Minor Amendments Supporting Document (10th February 2020)

Below is a table highlighting all minor amendments proposed as part of the NMA submission, along with their previously approved drawing & number, and the proposed amended drawing & number.

Proposed Car Park Sections – 254173-LPP-90-SW-L00-DES-L-0106-P4

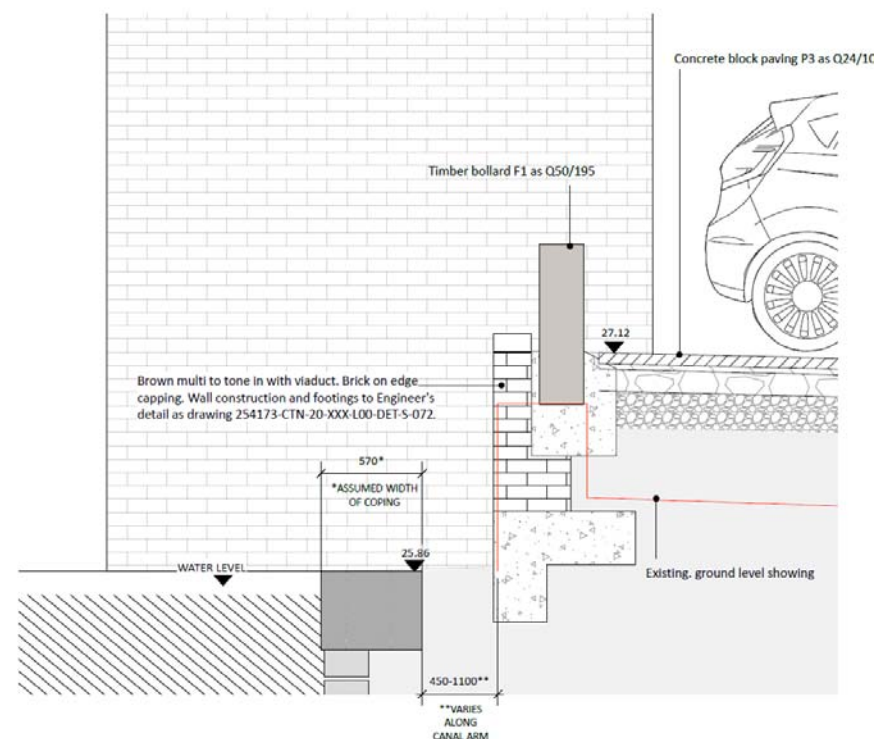
The above comparison indicates the minimal changes between the approved retaining edge of the car park, and what is now proposed where the levels have been increased. Brick choice will match the tone of the existing viaduct structure. Bond and mortar joints will also be of similar aesthetic.

Proposed Drawing - 254173-LPP-90-SW-L00-SEC-L-0301-P4

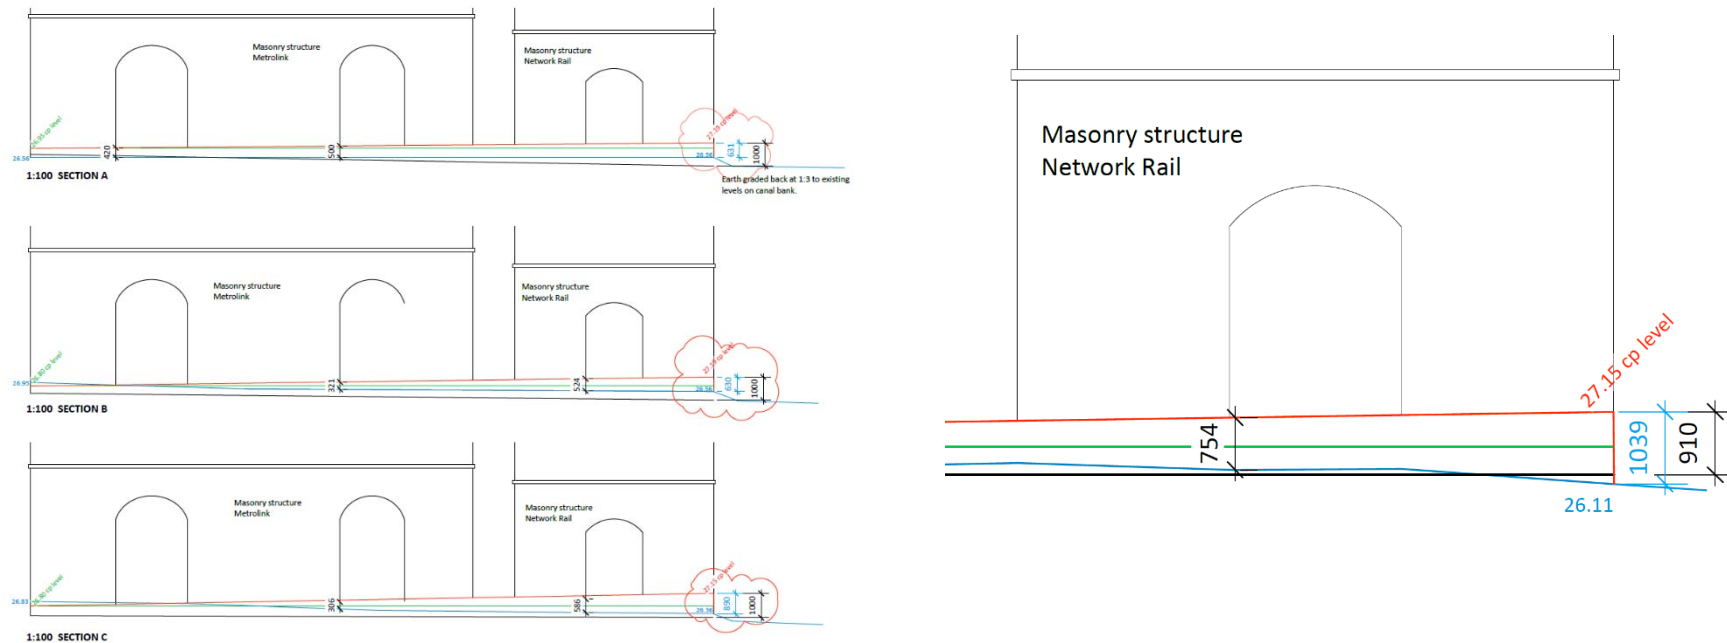
The above extract drawing 254173-LPP-90-SW-L00-SEC-L-0301-P4 highlights the changes in level between the previously approved application 118024/NMC.2017 (the lines shown in **GREEN**) and the proposed revised levels as part of this application 125388/NMC/2019 (the lines shown in **RED**).

The lines in **BLUE** show the existing ground level and the **BLACK** approved levels under the original application (109335/FO/2015/C1) – note it was originally intended to match existing but discrepancy between ground levels under the viaduct and those within the viaduct meant that this wasn't the case.

The view of the viaducts is retained & the increased levels will have no impact on this. The levels changes proposed in the context of the overall size / height of the existing viaducts is minimal.

Approved Drawing - 254173-LPP-90-SW-L00-DPL-L-0001-P11

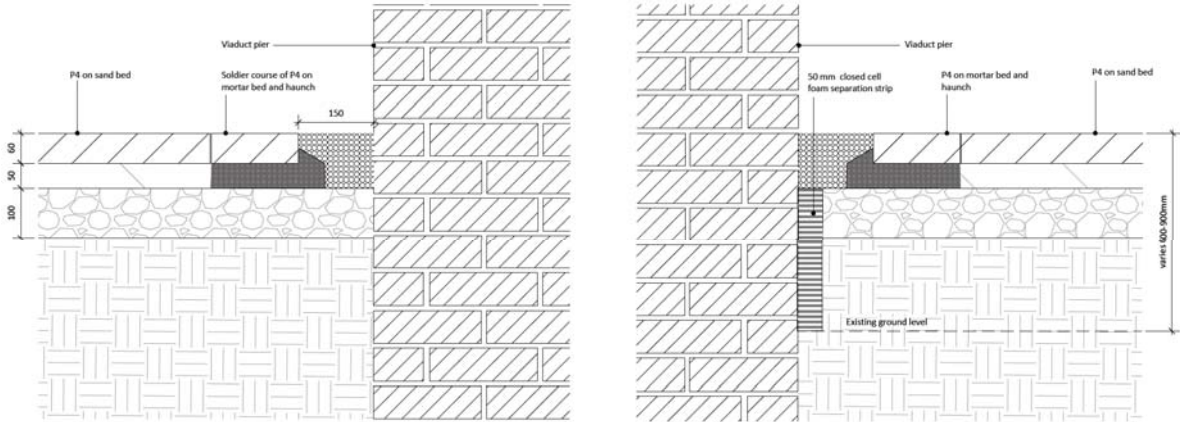
The above plan extracts show the relocation of two trees to ensure they don't clash with existing services. This should ensure that new trees thrive and grow more successfully and will not be disturbed by any future works required to these services.

Proposed Drawing - 254173-LPP-90-SW-L00-DPL-L-0001-P15

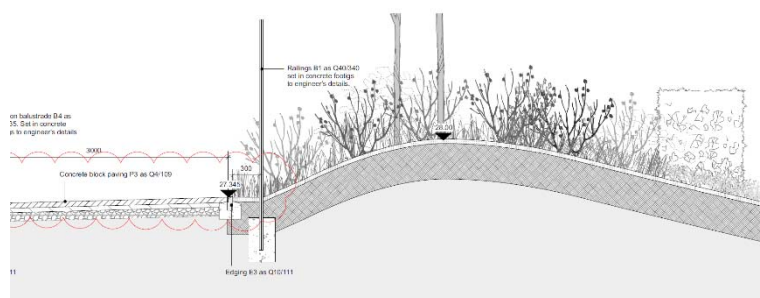
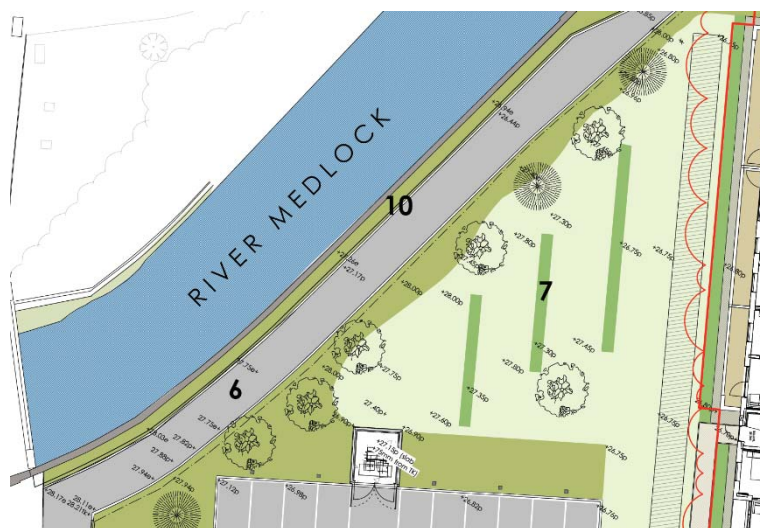
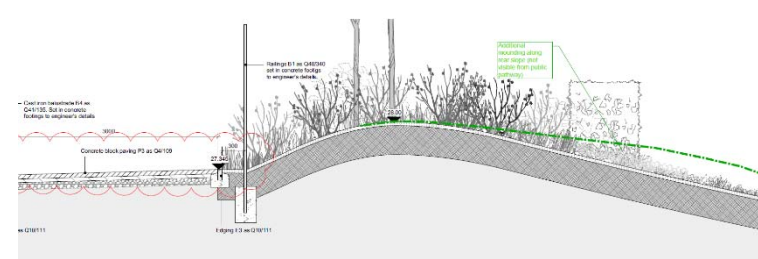
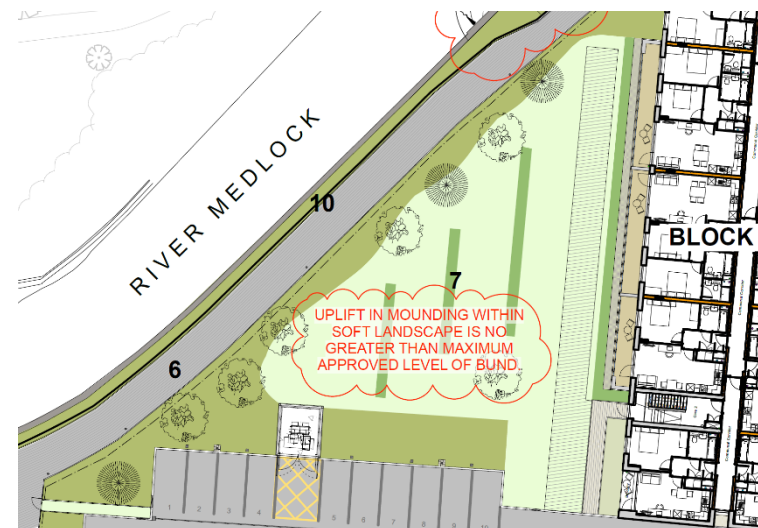
The above drawings shows the intended area for additional mounding, note the approval had a ridge line height of 28.00 alongside the river path – any additional mounding will be kept below this. The section above shows the detail of the approved mounding (note this didn't form part of the information submitted for planning)
